**Windward Development**  
**City of Issaquah**

**BERGSMA PRELIMINARY PLAT**  
**VARIANCE REQUEST**  
**DEVIATION REQUEST**

### **STREAM BUFFER IMPACTS**

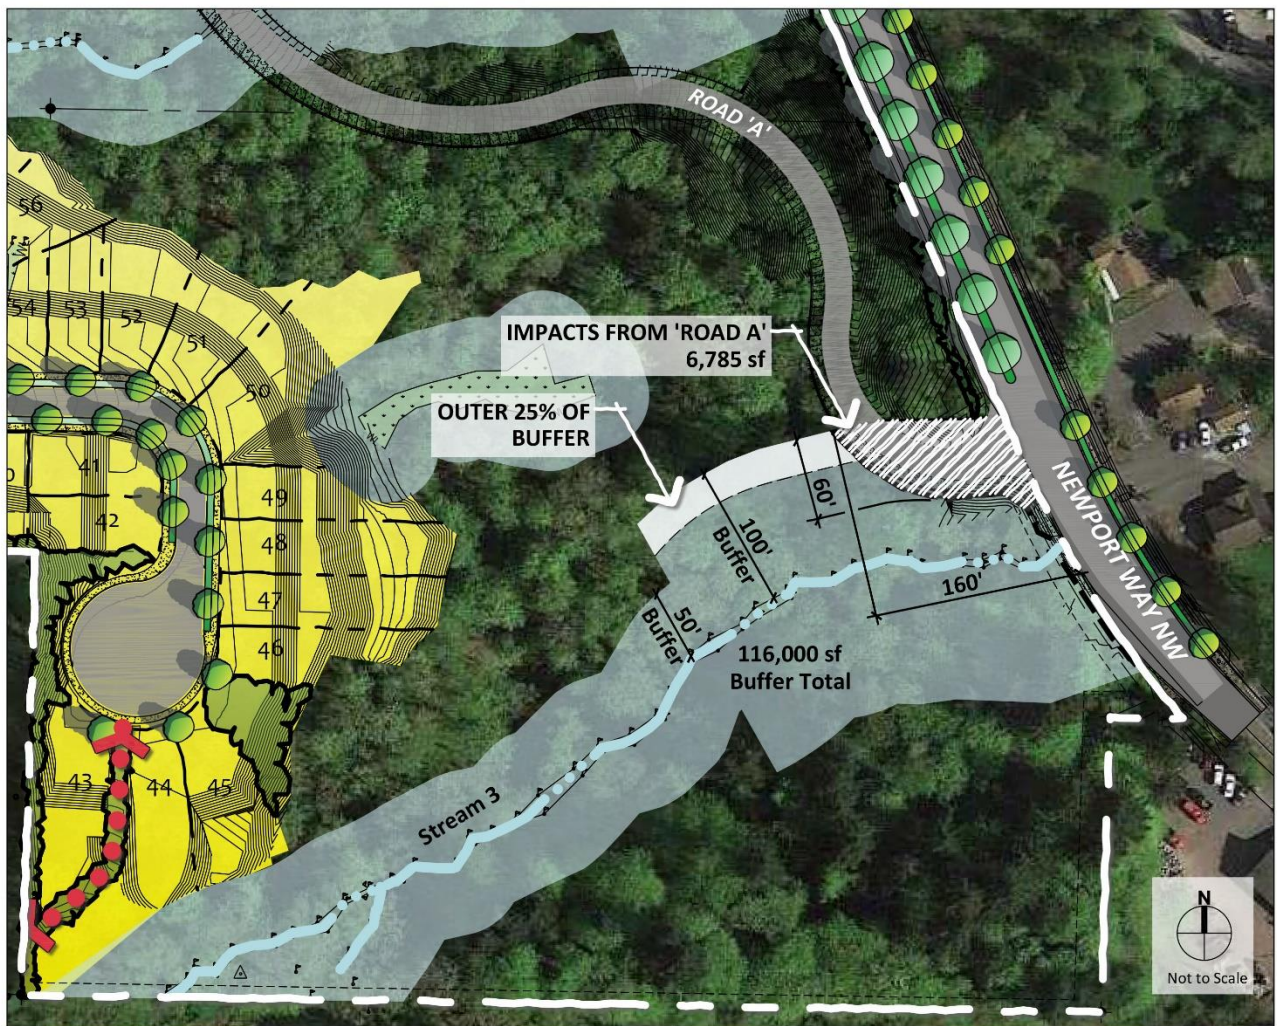
***The applicant is seeking authorization to allow for the modification of stream buffers in selected locations. A riparian buffer area along the bank of a stream separates the water from development areas such as lawns, buildings, roads, and driveways. Buffers are complex micro-environments that include grass, shrubs, and trees which hold the soil in place and act as living filters of pollution. The variance is focused on the intrusion of the "Entry Road" in the outer 50% of Stream 3 for a distance of 200 LF. Stream 3 is a Type F/Class 2 resource with a 100-foot buffer at the lower area of the site. This is a unique steep site condition with frontage on Newport Way NW. The Bergsma property has limited opportunities to create a new public street intersection meeting design standards.***

***The impact is unavoidable. The development proposal will direct water from pollution-generating surfaces into engineered conveyance systems and water quality and detention facilities. Stream buffer vegetation enhancements are proposed, including removal of non-native invasive plants and replacement with appropriate material suitable for the habitat of the northwest.***

***Stream 3 is buffered by more than 116,000 SF of buffer on the site, the intrusion of 9,400 SF represents a less than 8% impact.***

The applicant is seeking approval to modify the requirement of the applicable **City Code 18.10.790(D)1** in accordance the following criteria:

1. The variance will achieve the intended result in equivalent:
  - ***Protection of the stream environment is the goal of the development. The stream is proposed to be protect by upgraded stream buffers enhanced with removal of non-natives/invasive species and re-planted with material suitable for this context.***
  - ***Additionally, the stream will receive appropriate quantities of the clean rainwater from rooftops that will be conveyed and released in a conveyance system to avoid a point discharge erosion hazard.***
2. The variance addresses public safety and operation.

**PUBLIC ROAD THROUGH CRITICAL SLOPES**

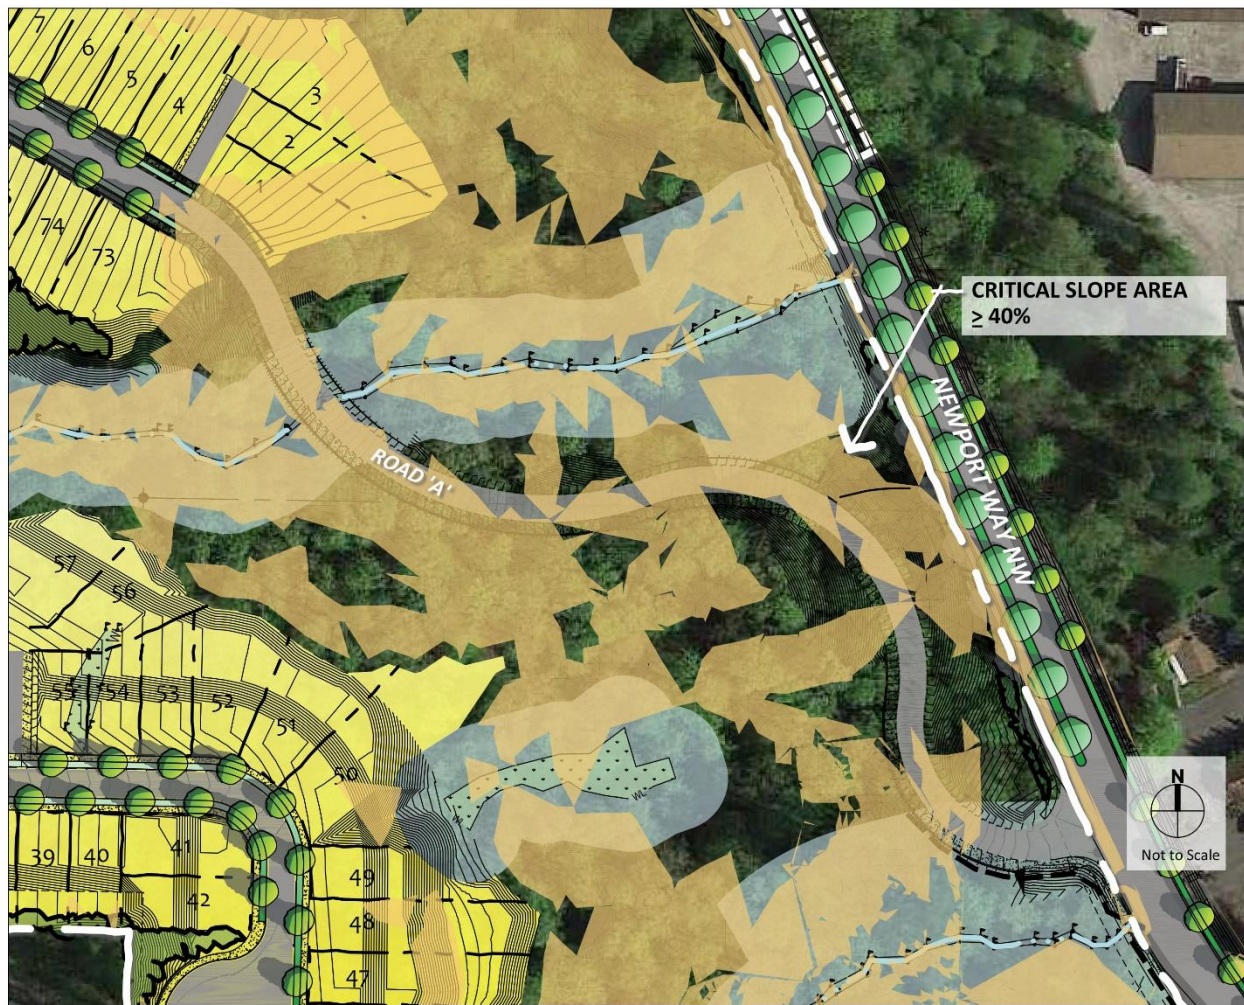
***The applicant is seeking authorization to allow for the location of the entry road in portion of the site where grades exceed 40%. Slopes of 40% or greater are regulated as potential hazard areas.***

***Whereas the unique context of this residential property encourages high-end density and development, accessing the developable portion of the site requires development of an access roadway across the steeper slopes. The access roadway will traverse the slope, complying with applicable and modified (see roadway deviations) standards. The roadway is designed for two travel lanes and a pedestrian sidewalk. The centerline grade will not exceed 15%. The roads will be designed by experienced professionals (Biologist, Geotechnical Engineer, Structural Engineer, and Civil Engineers collaborating to manage the environmental impact of development and the range of mitigation options to ensure a safe travel way for the public. The access road impacts about 29,310 SF of the 959,400 total SF onsite.***

The applicant is seeking approval to modify the requirement of the applicable **City Code, IMC 18.10.580(B)3B, 1-6**. in accordance the following criteria:

1. The variance will achieve the intended result in equivalent:
  - ***The intent of the code is to manage and protect harmful impacts to the environment. The development of the entry road (street A) will include a great deal of professional design attention to ensure impacts are mitigated.***
2. The variance addresses public safety and operation; the code seeks to protect the public by providing safe travel ways in concert with environmental management.
3. The variance will not adversely affect how well the surrounding nearby public facilities can be maintained.
  - ***Public facilities will not be harmed by this variance.***

**STORMWATER VAULT IN CRITICAL SLOPES**

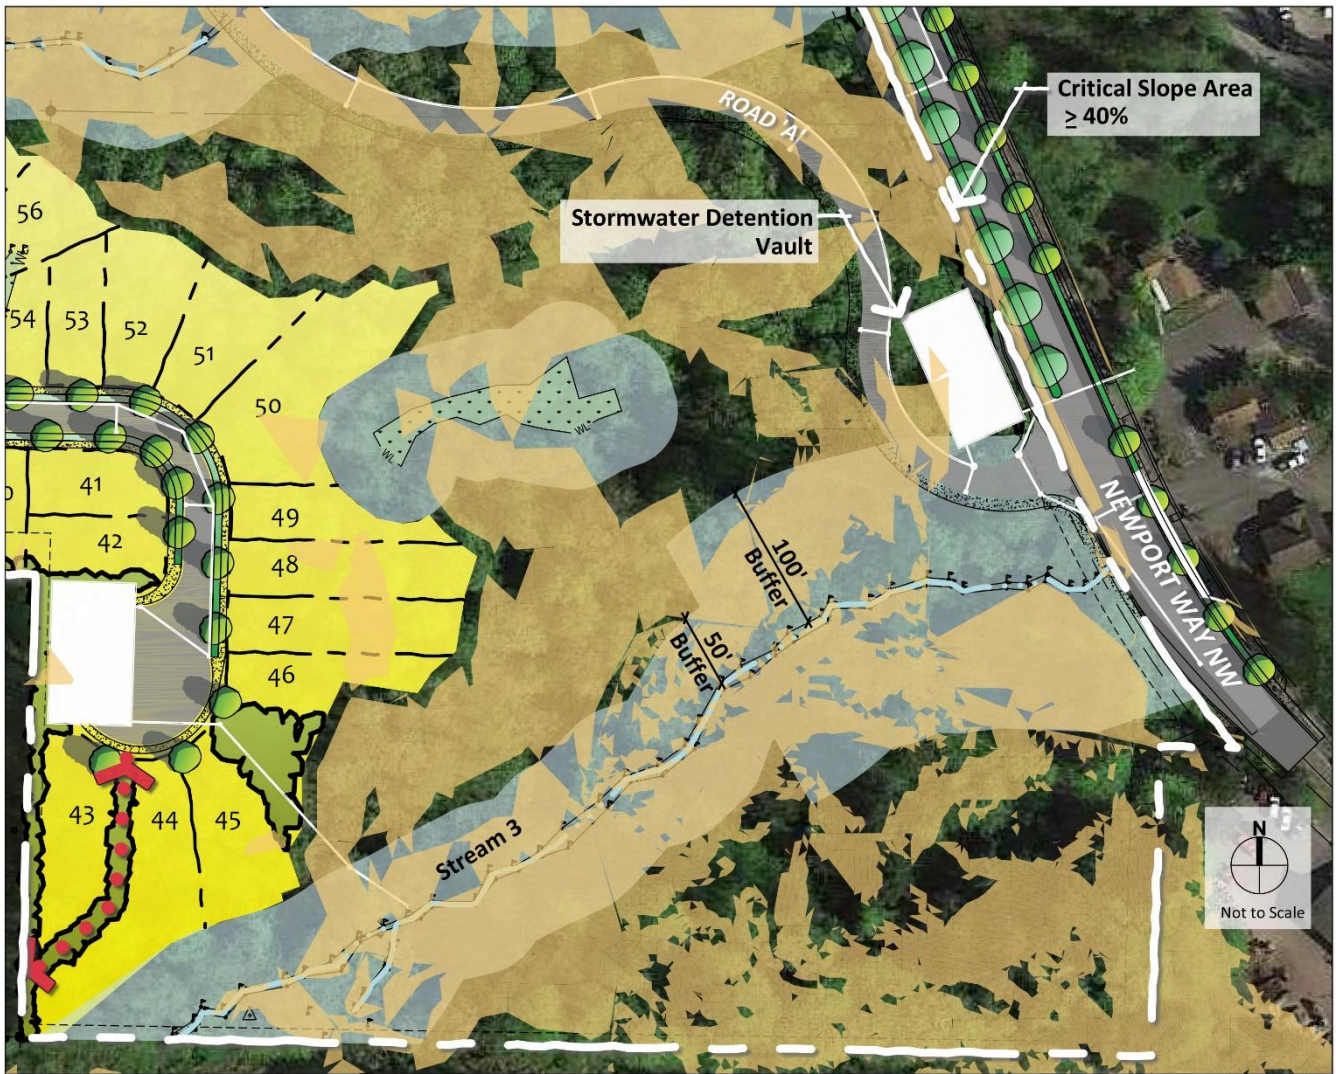
***The applicant is seeking authorization to allow for the location of a stormwater detention vault in an area currently defined as a steep slope/critical area near the intersection of the Entry Road and Newport Way NW. The location of the vault is primarily driven by the location of the plat's Entry Road. The location of the entry road is guided by the limiting factors contained in the City design standards. The limiting factors include maximum grade and visual impact on the heavily treed and steep property.***

***The vault is the detention facility that is designed to receive runoff from a large area of the site.***

***Whereas the unique context of this residential property encourages high-end density and development, accessing the developable portion of the site requires development of an access roadway across the steeper slopes. The access roadway will traverse the slope, complying with applicable and modified standards (see roadway deviations). The roadway is designed for two travel lanes and a pedestrian sidewalk. The centerline grade will not exceed 15%. The roads will be designed by experienced professionals (Biologist, Geotechnical engineer, Structural Engineer, and Civil Engineers) collaborating to manage the environmental impact of development and the range of mitigation options to ensure a safe travel way for the public. The stormwater vault impacts about 800 SF of the 959,400 total SF onsite.***

The applicant is seeking approval to modify the requirement of the applicable **City Code, IMC 18.10.580(B)3B, 1-6.** in accordance the following criteria:

1. The variance will achieve the intended result in equivalent:
  - ***The intent of the code is to manage and protect harmful impacts to the environment. The development of the entry road (street A) will include a great deal of professional design attention to ensure impacts are mitigated.***
2. The variance addresses public safety and operation; the code seeks to protect the public by providing safe travel ways in concert with environmental management.
3. The variance will not adversely affect how well the surrounding nearby public facilities can be maintained:
  - ***Public facilities will not be harmed by this variance.***

**Windward Development / City of Issaquah**  
**DEVIATION REQUEST #1: Road A (up the hill) – Modified Street Section**

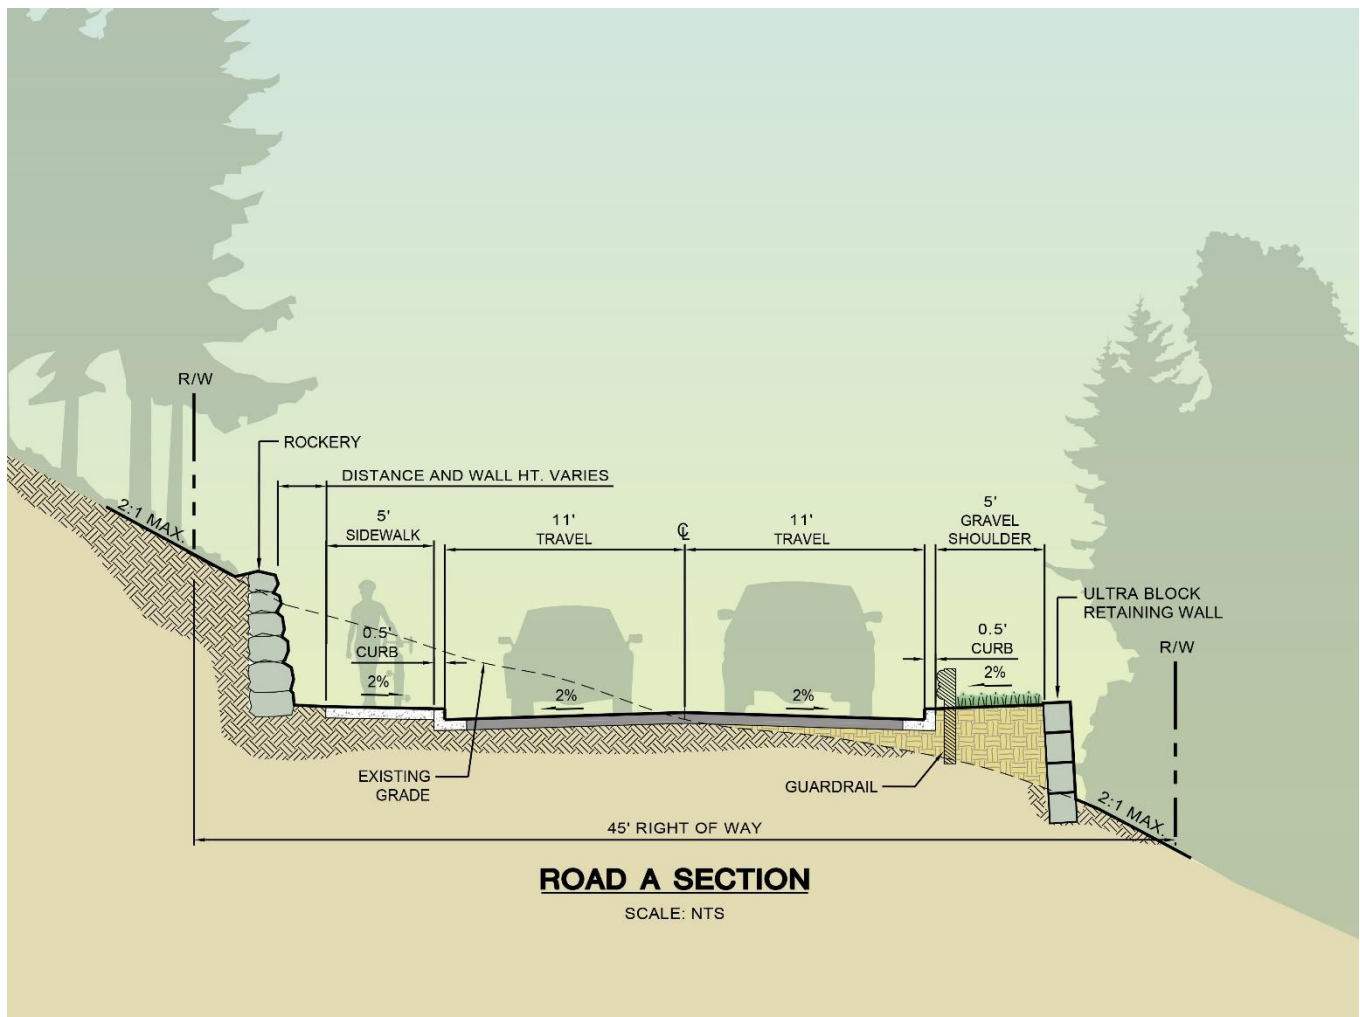
*The applicant is seeking to modify the identified street standard to;*

- ***Centerline Street Grade: up to 14.99%***
- ***Right-of-Way: Reduced to 45' (min)***
- ***Travel Lanes: 2 at 11' each with vertical curb***
- ***Rockery Wall on the uphill cut slope, separated from vertical curb by a 5' sidewalk and a 4'+/- gravel shoulder with a total separation of 9'+/-.***
- ***Ultra-block Wall on the downhill fill slope, separated from vertical curb by 5.5' gravel shoulder and guardrail placed at the face of curb for a safety zone.***
- ***Deletion of Planter Strip, given the forested natural context***
- ***Design Speed of: 25 mph***
- ***Posted Speed: 25 mph***
- ***Design Centerline Radius: 95' min.***
- ***Stopping Sight-line distance of: 200' min.***

The applicant is seeking approval to modify the requirement of the applicable **City of Issaquah, Public Works Department, Typical Public Local Access Street (<1,500 VPD Residential Areas, Standard Detail No. T-11 (11-10-11)** in accordance the following criteria:

1. The combined deviation will achieve the intended result in equivalent or superior design:
  - ***The modified road seeks to apply several roadway deviations to the design of the travel way. The combined deviation will provide two travel lanes (11' each) as well as a safe pedestrian sidewalk for the public. The deviation will provide for access to the site through the highly regulated and environmental constraints of the property. The modified centerline radius will reduce impacts and construction costs, and the modification of side slopes/cut slopes with retaining walls to the road corridor will provide safe stopping sight distance sightlines for the roadway. Streetlights will be provided with 300-foot spacing between poles. Additionally, the collaboration of transportation standards and a reduced environmental impact will collectively advocate for a reduction of the area required for grading, clearing, and tree removal.***

2. The deviation addresses public safety and operation.
  - ***The deviation is designed to ensure the ongoing high priority of public safety and operation of the public right-of-way. The roadway will provide standardized sight distance view lines through the curves to facilitate the enhanced view for drivers to see far ahead.***
3. The deviation will not adversely affect how well the surrounding nearby public facilities can be maintained:
  - ***The deviation, as proposed and potentially approved by the City Engineer, will not adversely affect surrounding public facilities.***

**Windward Development / City of Issaquah**  
**DEVIATION REQUEST #2: Road B (Local Street) Modified Street Section**

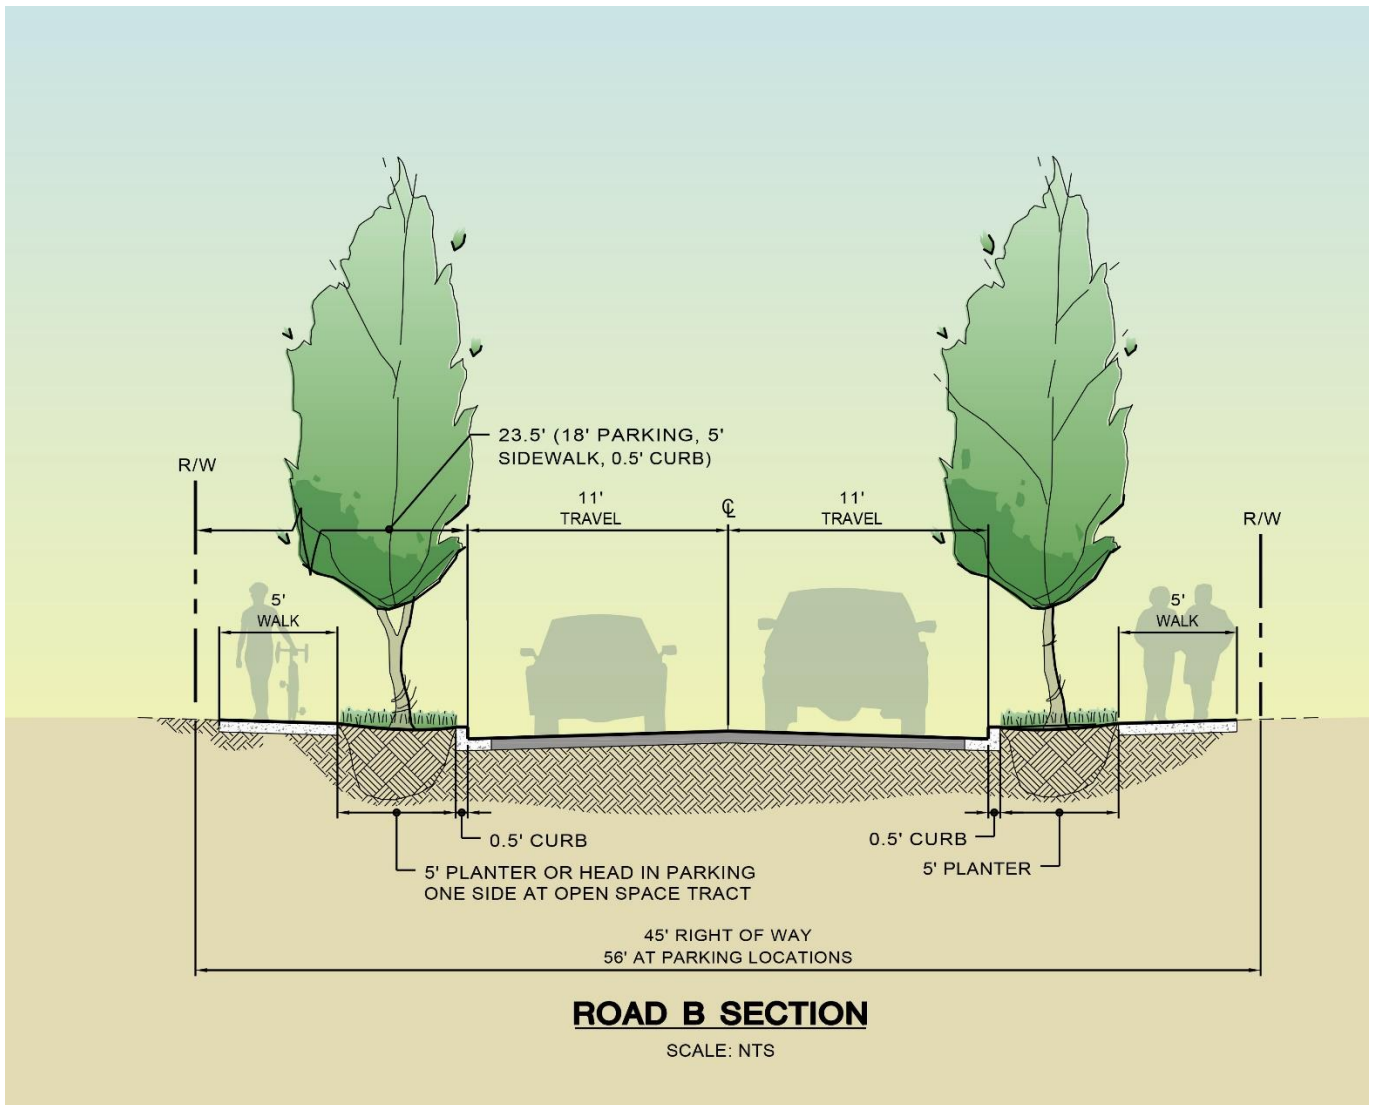
**DESCRIPTION OF DEVIATION:** *The applicant is seeking to modify the identified street standard to;*

- ***Right-of-Way: Reduced to 45'/56' (min)***
- ***Travel Lanes: Two at 11' each with vertical curb***
- ***Planter strip at back of curb both sides***
- ***Pedestrian Sidewalk: Both sides of street***
- ***Parallel Parking at Open Space pockets as opportunities present, see plan***

The applicant is seeking approval to modify the requirement of the applicable **City of Issaquah, Public Works Department, Typical Public Local Access Street (<1,500 VPD Residential Areas, Standard Detail No. T-11 (11-10-11))** in accordance the following criteria:

1. The deviation will achieve the intended result in equivalent or superior design;
  - ***The deviation will provide for the opportunity to provide standard residential driveways guest parking, as parallel spaces as opportunities are available.***
2. The deviation addresses public safety and operation:
  - ***The deviation is designed to supplement parking options in addition to those located in the residential driveways.***
3. The deviation will not adversely affect how well the surrounding nearby public facilities can be maintained:
  - ***The deviation as proposed will not adversely affect surrounding public facilities.***
